**Southern Connecticut
State University**

Wintergreen - Food Pantry, Break Room, Conference Room - 2020

Project Number: SCSU-2020-02

ADDENDUM NO. 1

1 FIRST FLOOR OVERALL PLAN - WINTERGREEN BUILDING
 A7 SCALE: 1/8" = 1'-0"

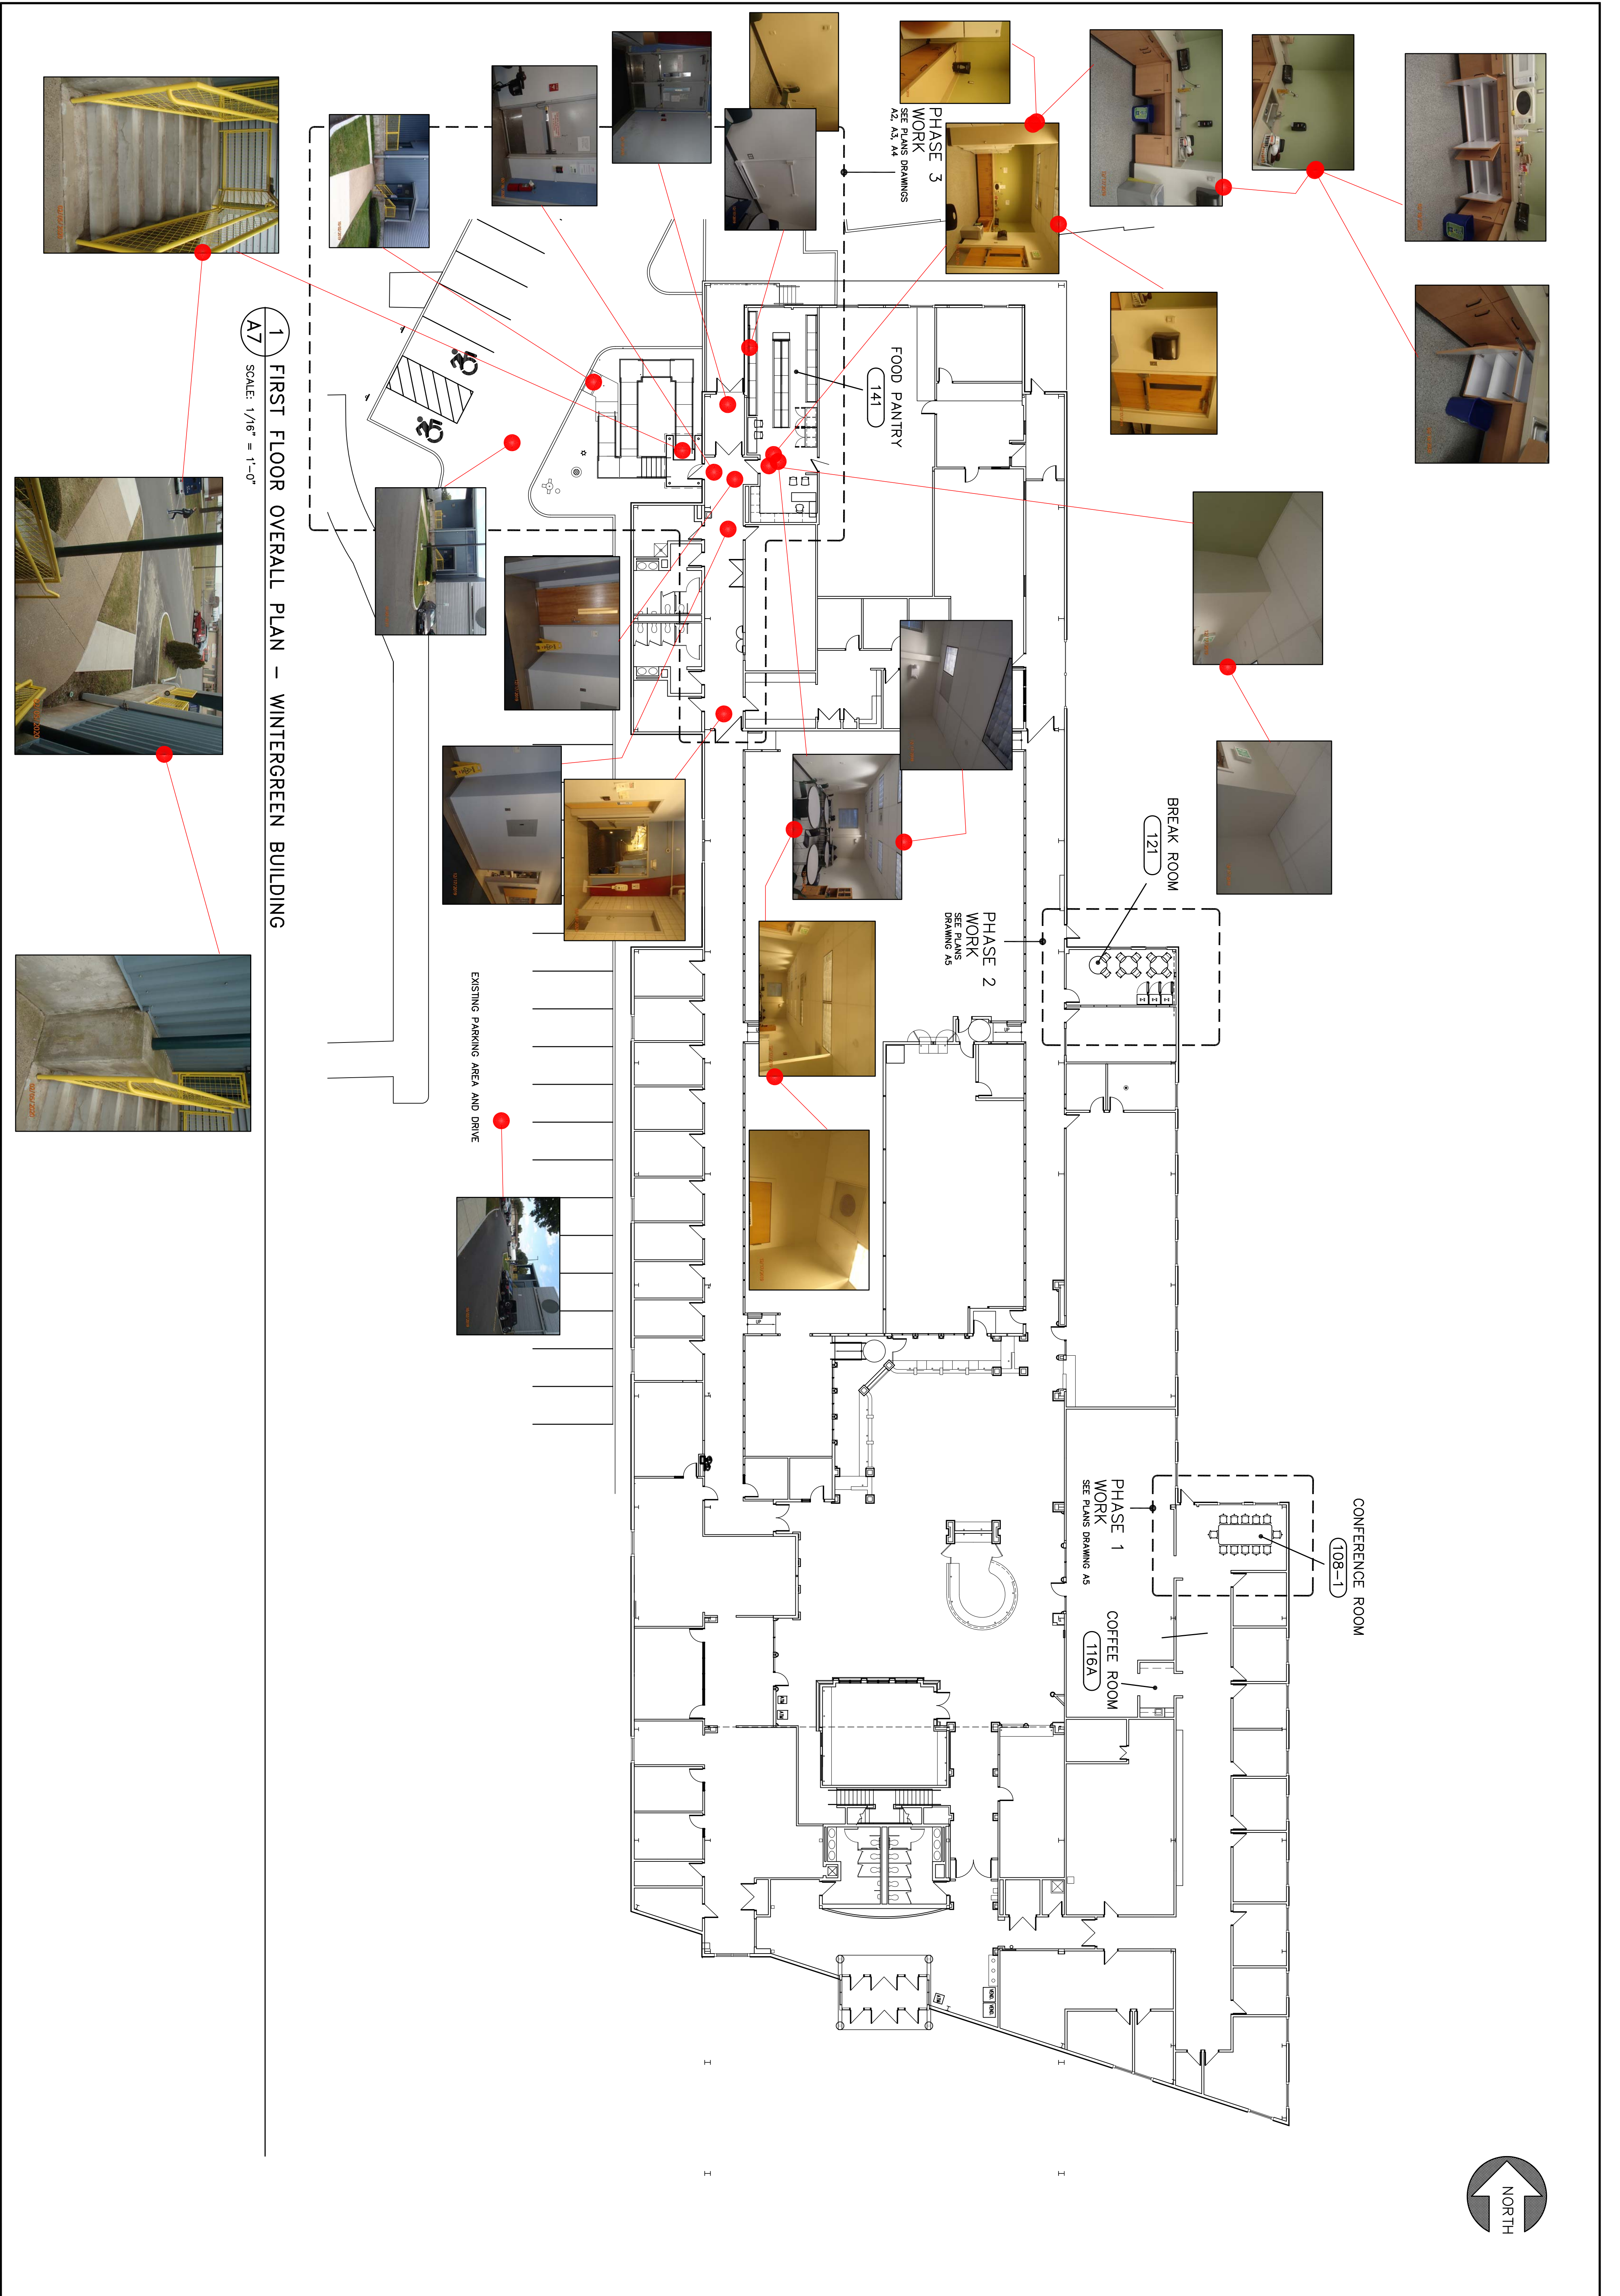
Drawing A7, with existing conditions pictures of the building outside and of the future Food Pantry Area.

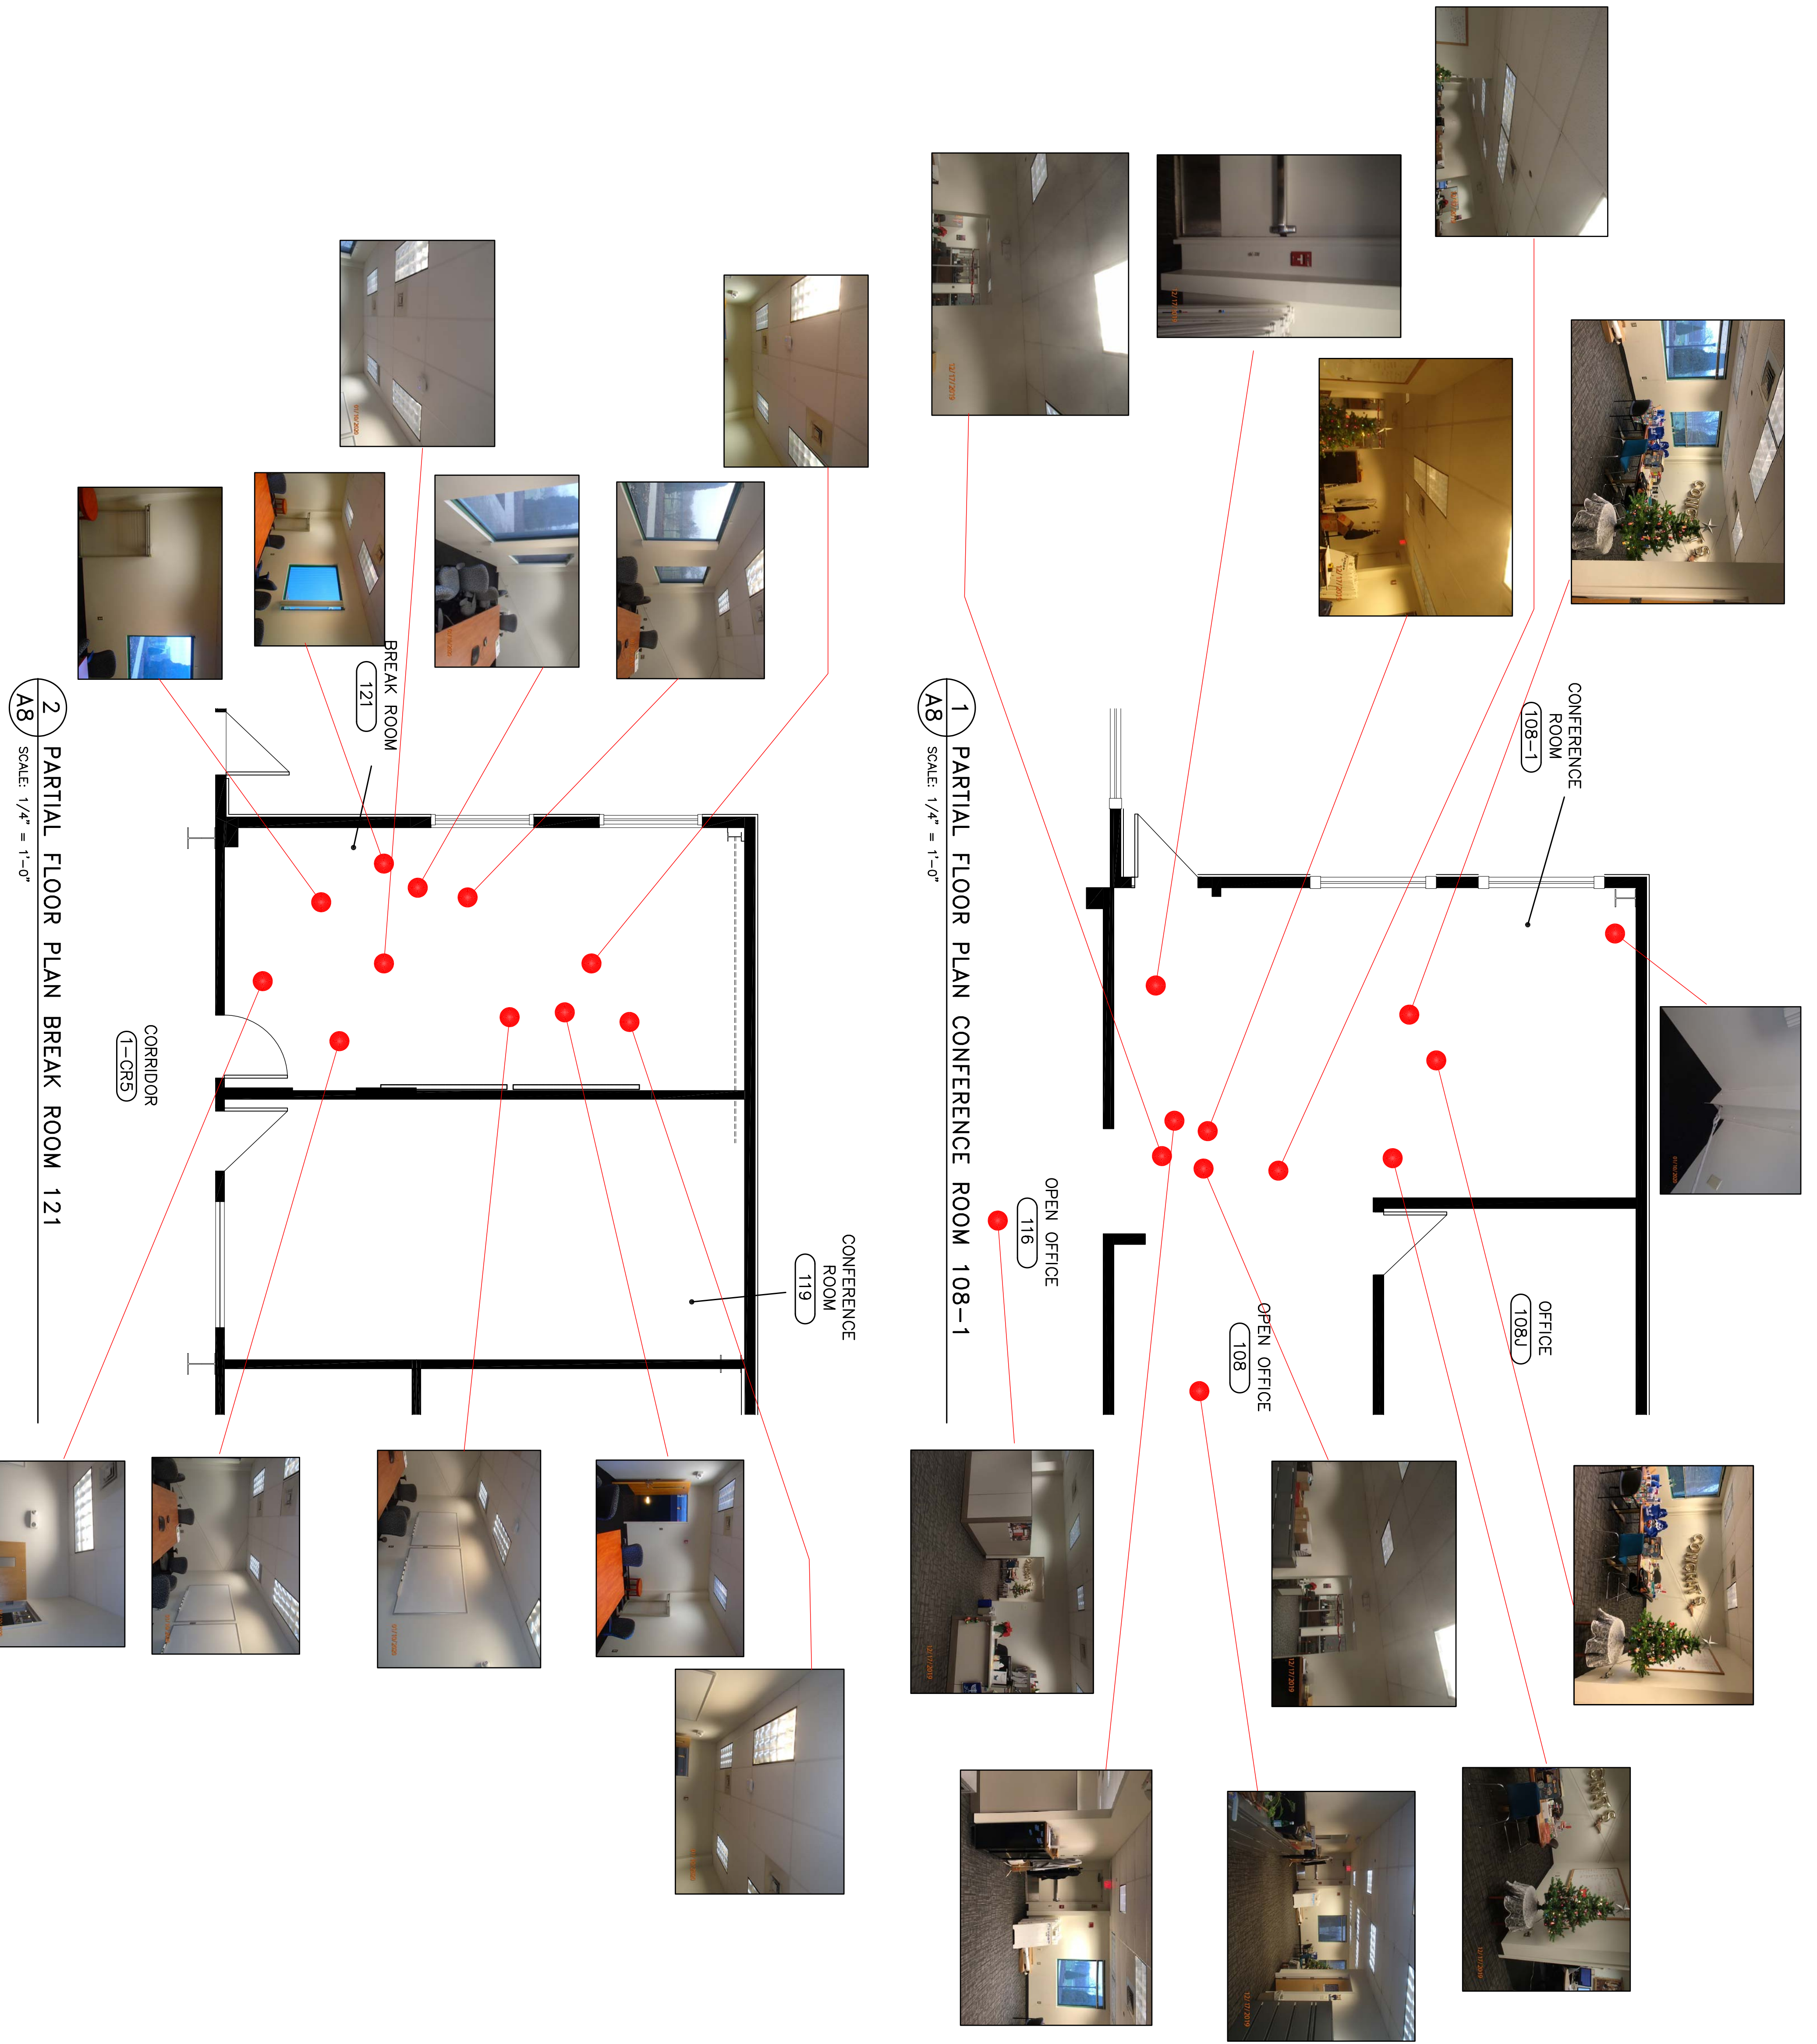
Drawing A8 with existing conditions pictures of the future Conference Room, 108-1, and the Break Room, 121.
